**STATE OF CONNECTICUT
CONNECTICUT SITING COUNCIL**

IN RE: :
 :
 : DOCKET NO. 510
 :
 NEW CINGULAR WIRELESS PCS, LLC :
 D/B/A AT&T AND TARPON TOWERS II, :
 LLC APPLICATION FOR A CERTIFICATE :
 OF ENVIRONMENTAL COMPATIBILITY :
 AND PUBLIC NEED FOR THE :
 CONSTRUCTION, MAINTENANCE AND :
 OPERATION OF A :
 TELECOMMUNICATIONS FACILITY : August 1, 2022
 LOCATED AT 92 GREENS FARMS ROAD,
 WESTPORT, CONNECTICUT

**NEW CINGULAR WIRELESS PCS, LLC D/B/A AT&T AND TARPON
TOWERS II, LLC RESPONSES TO CONNECTICUT SITING COUNCIL
PRE-HEARING INTERROGATORIES DATED JULY 8, 2022**

Existing Coverage
2100 MHz LTE

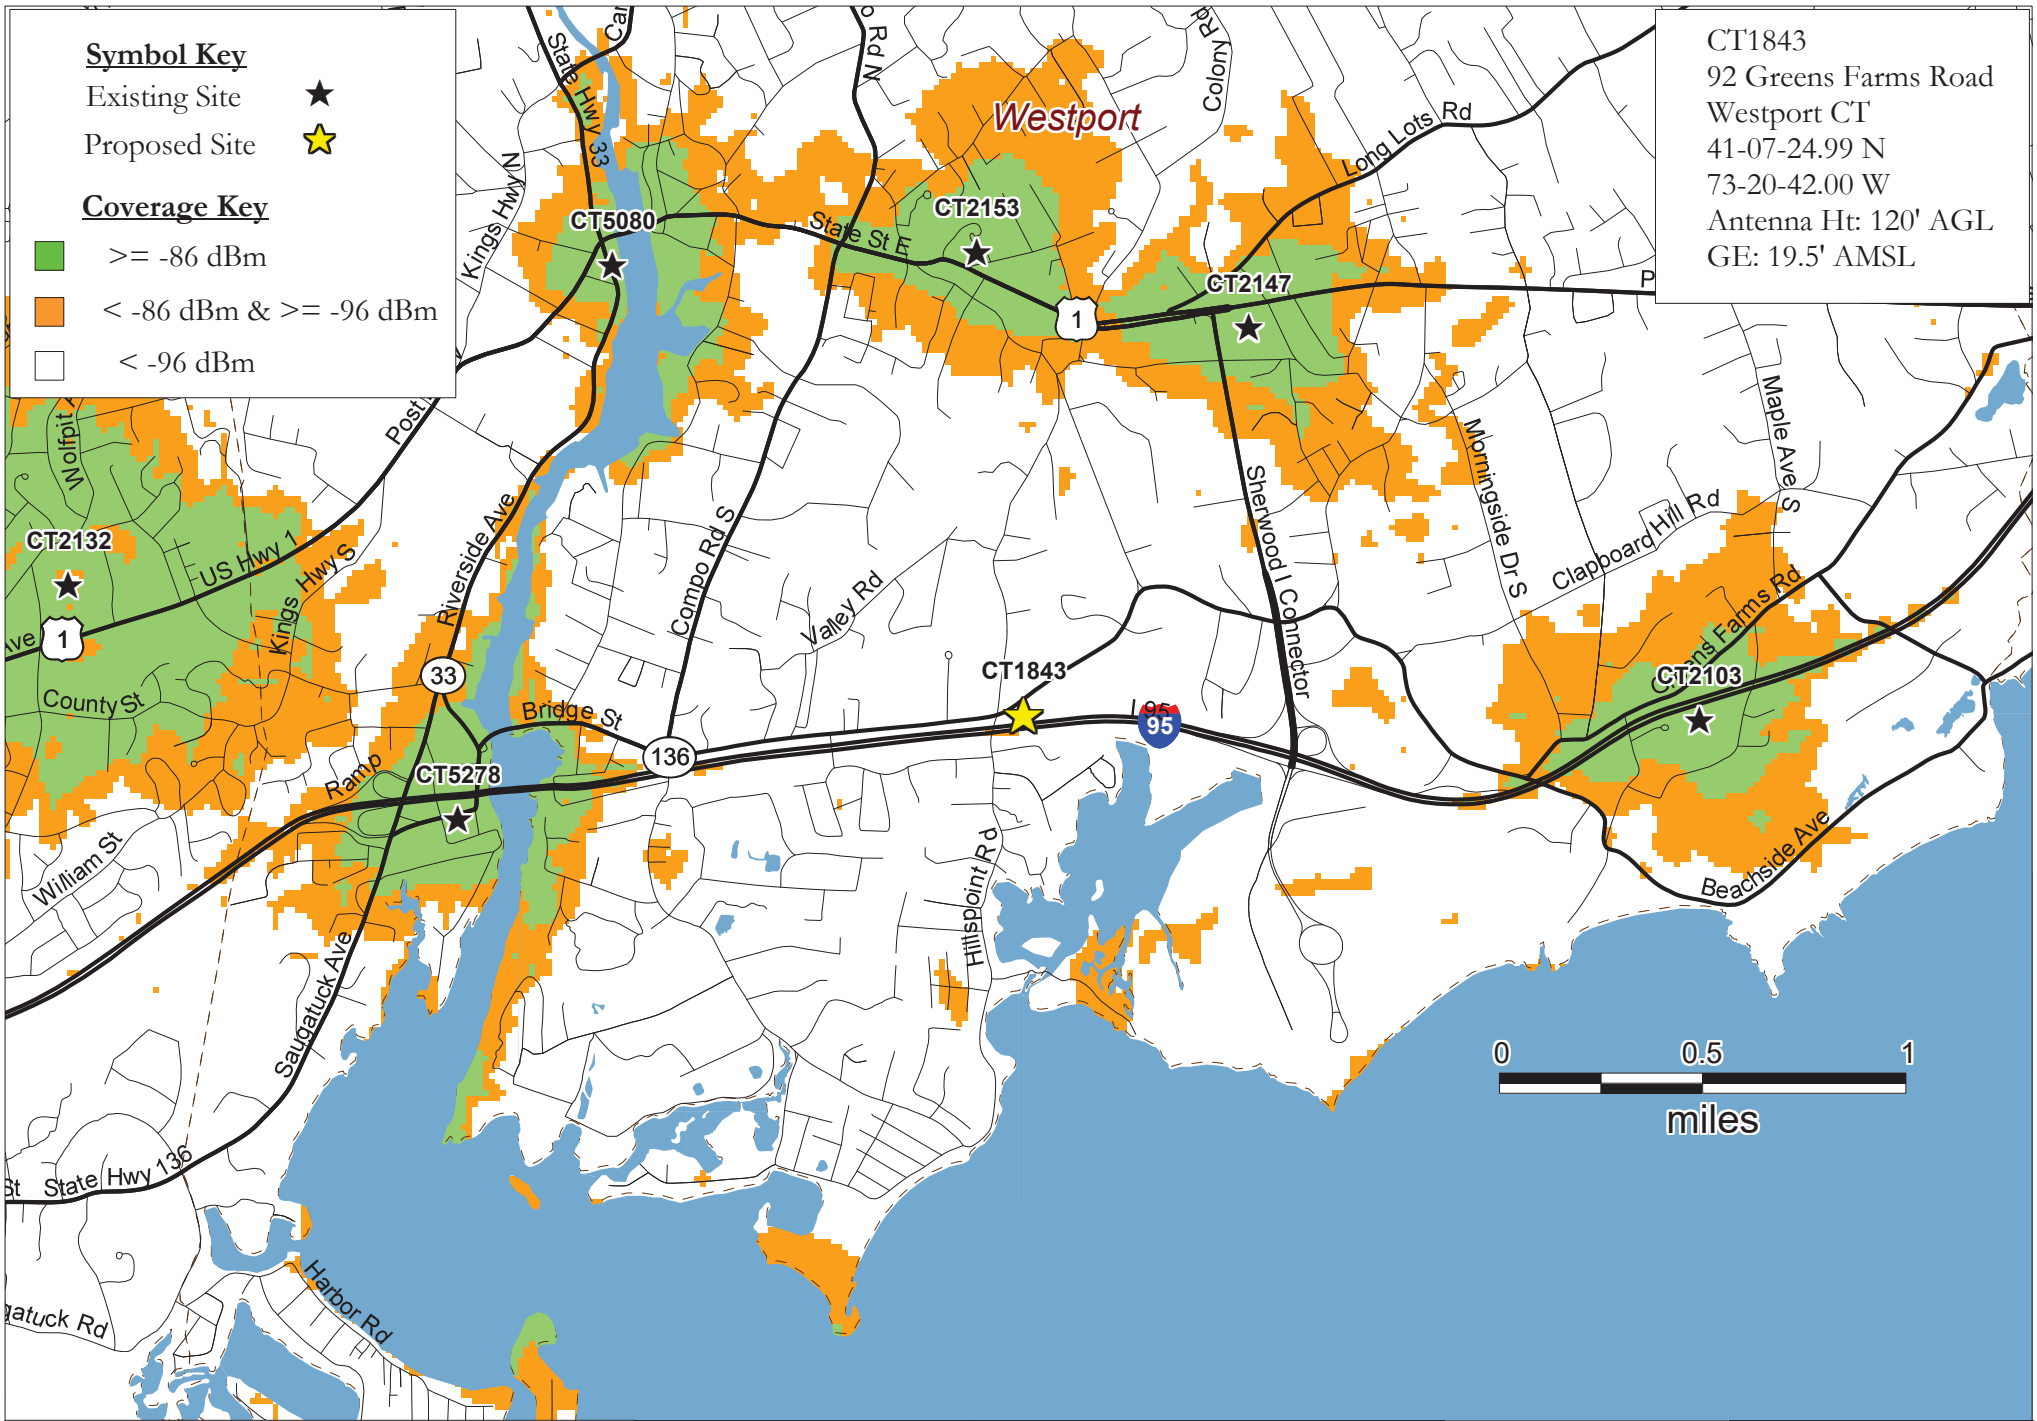
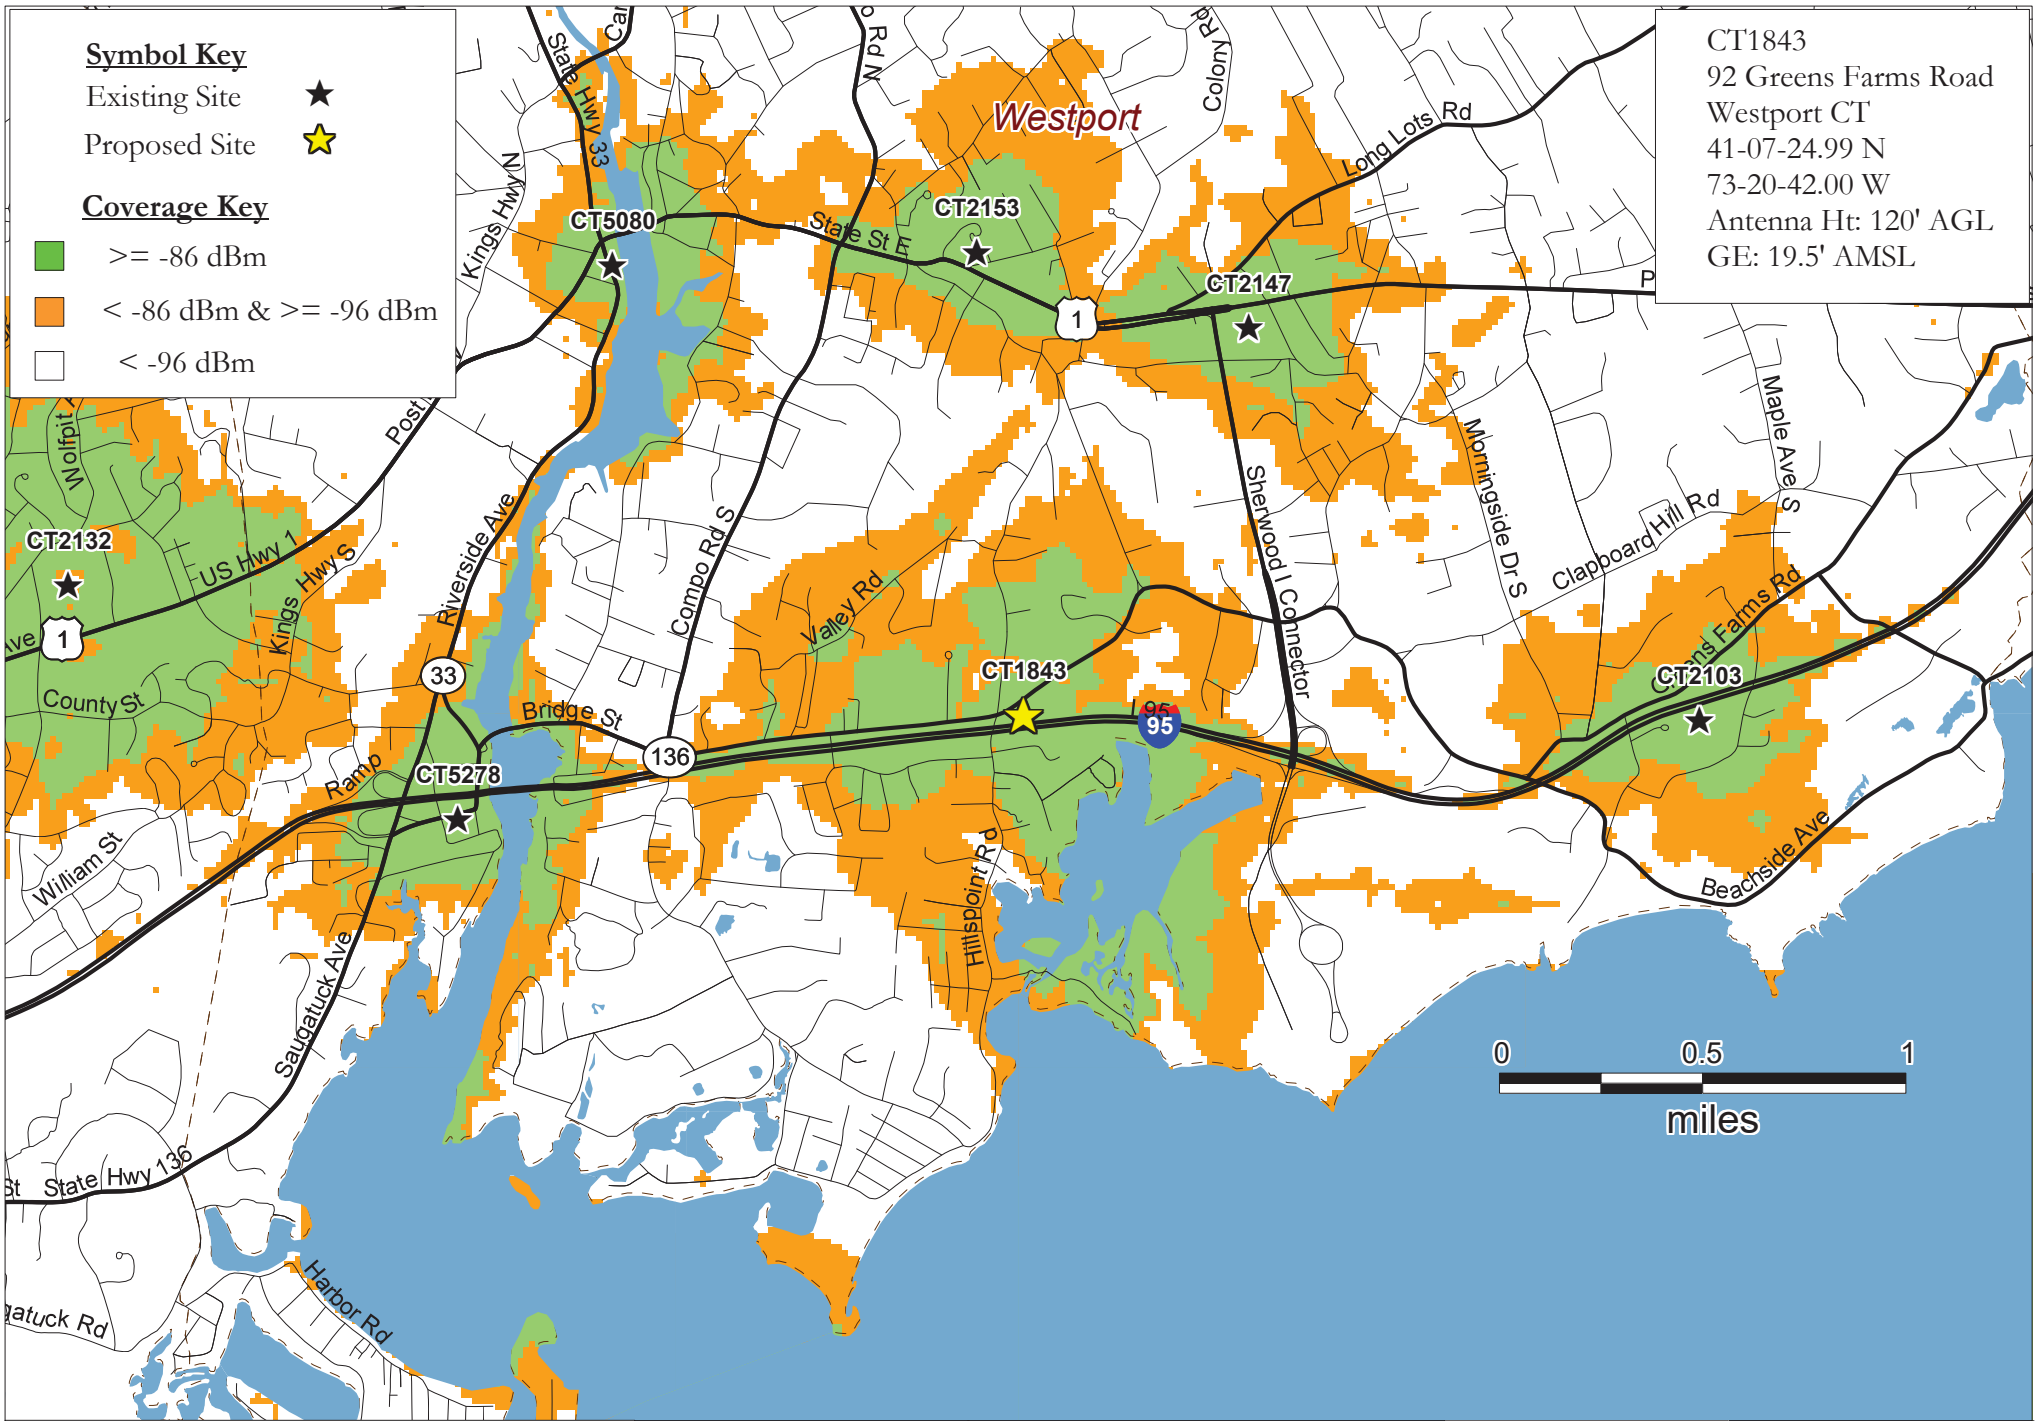
28. Provide coverage models for existing and proposed 1900 MHz, 2100 MHz and 3500 MHz services.

Please see plots included in Exhibit 28 attached hereto.

Please see the coverage plots included in Exhibit 28. The predicted coverage footprints are as follows:
